CITY OF ALBUQUERQUE

**RE: Volcano Cliffs Subdivision Lot 18, Block 4, Unit 19
6535 Vista Del Prado Dr. NW
Grading and Drainage Plan
Engineers Stamp Date 5/19/17 (D10D003T18)
Pad Certification date 6/27/17**

RE: Pad Certification by Engineer of Record

GRADING AND DRAINAGE PLAN

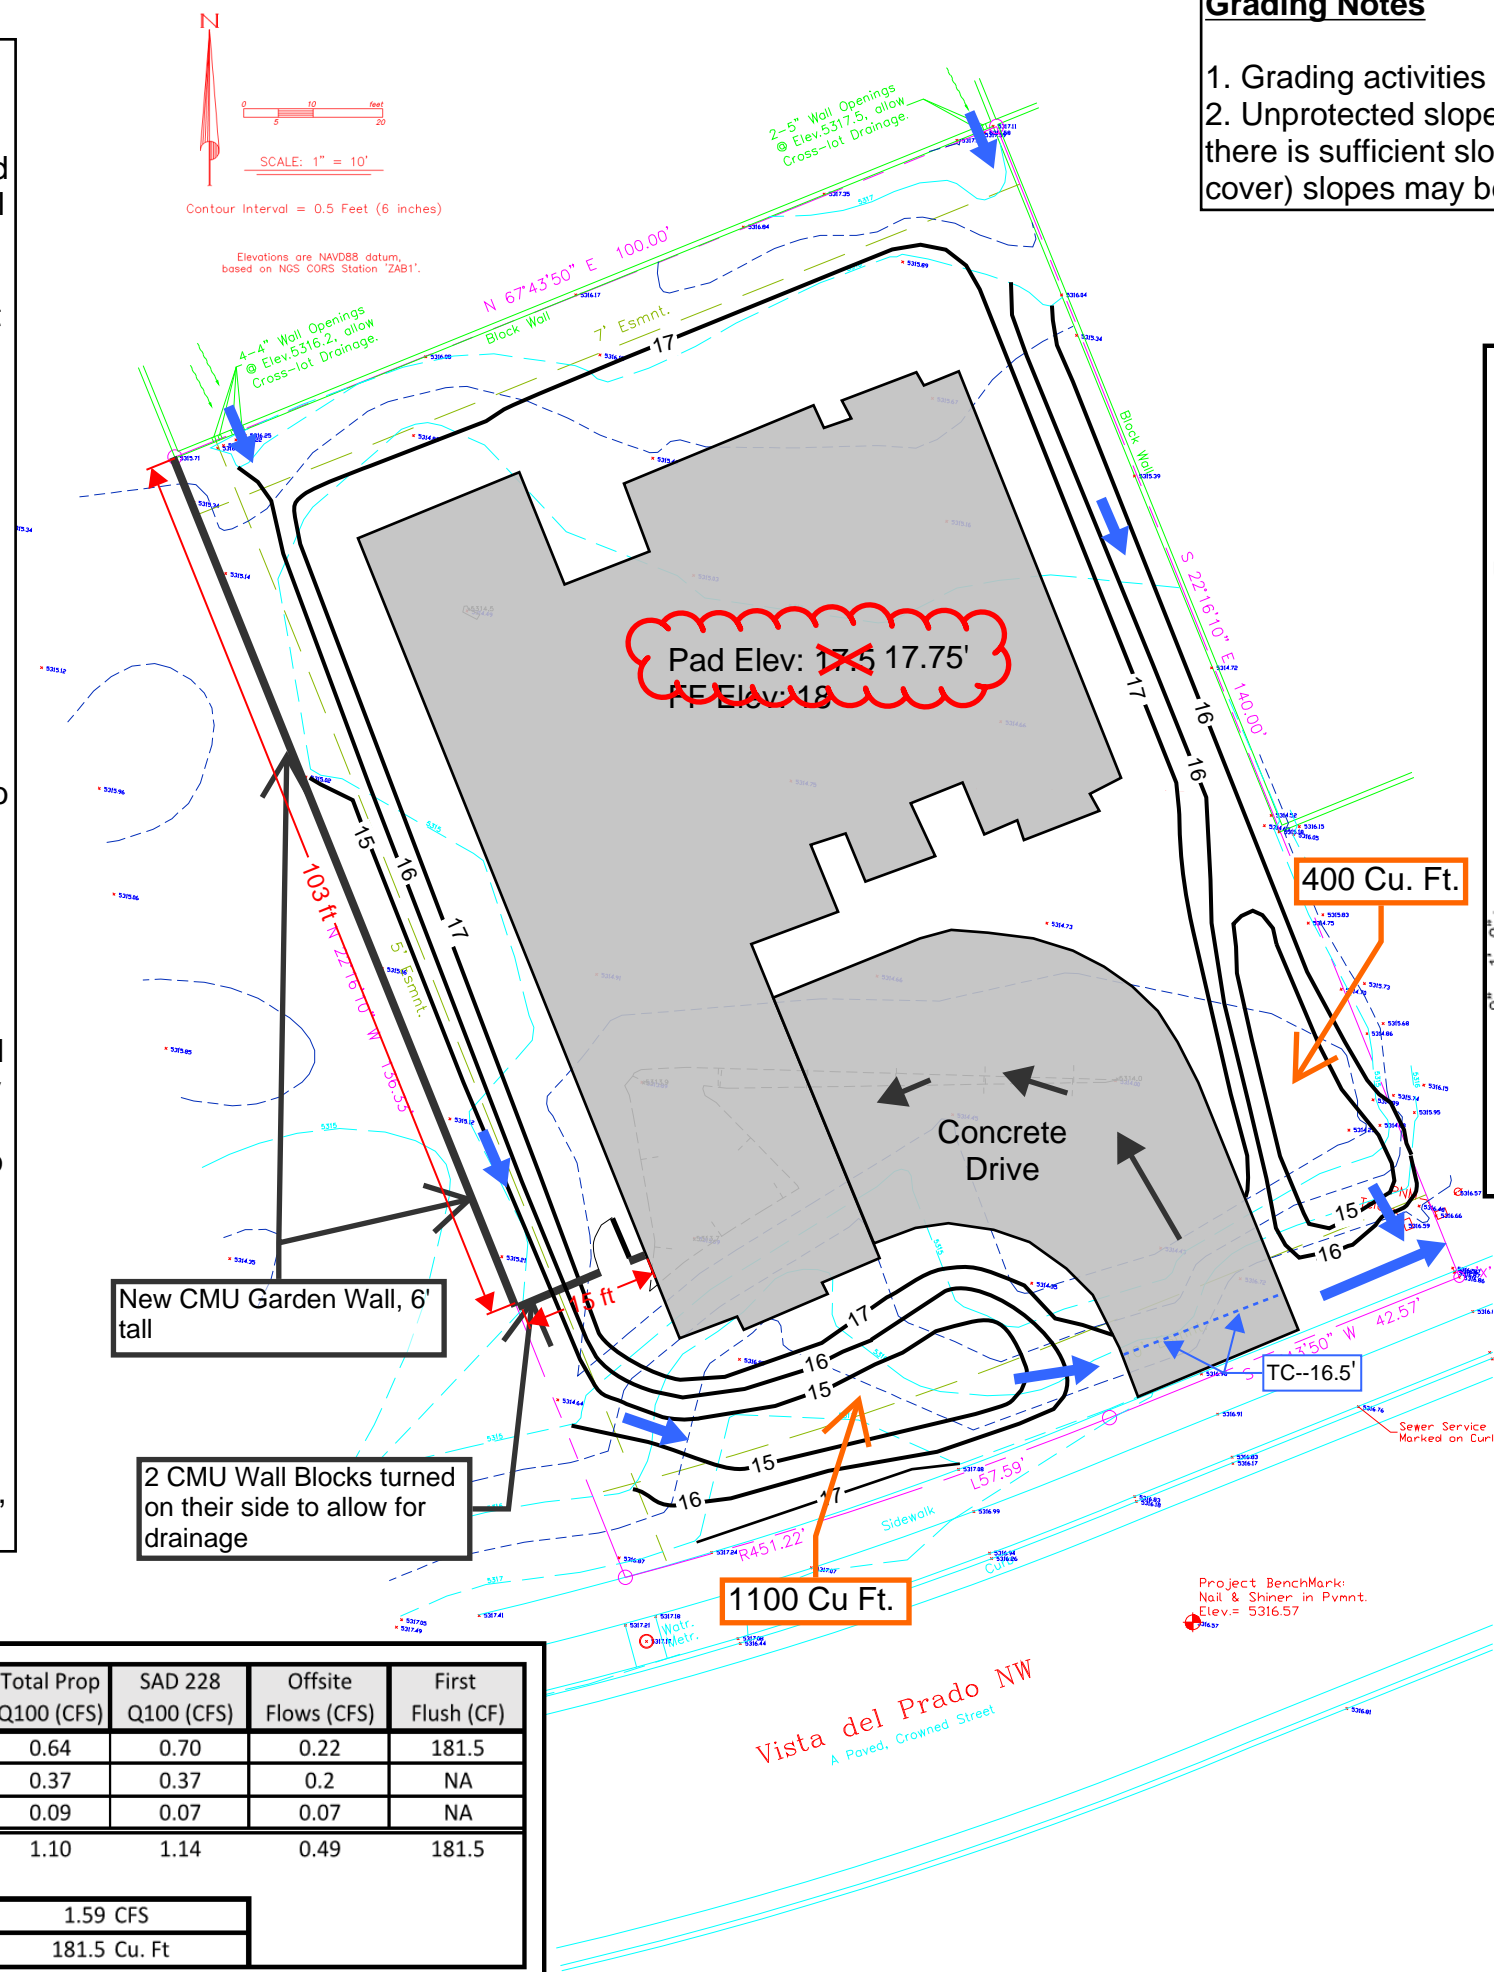
Based upon the information provided in your submittal received 6/30/17, this plan is approved for Building.

Please attach a copy of this approved plan to the construction sets in the permitting process prior to sign-off by Hydrology. Also, please advise the owner/contractor that a separate wall permit must be obtained and this approved grading plan dated 5/19/17, pad certification dated 6/27/17 must be provided with the wall permit application. Also, please advise the contractor/owner that the ponds must stay in place or CO will not be granted.

Prior to Certificate of Occupancy release, Engineer Certification per the DPM checklist will be required.
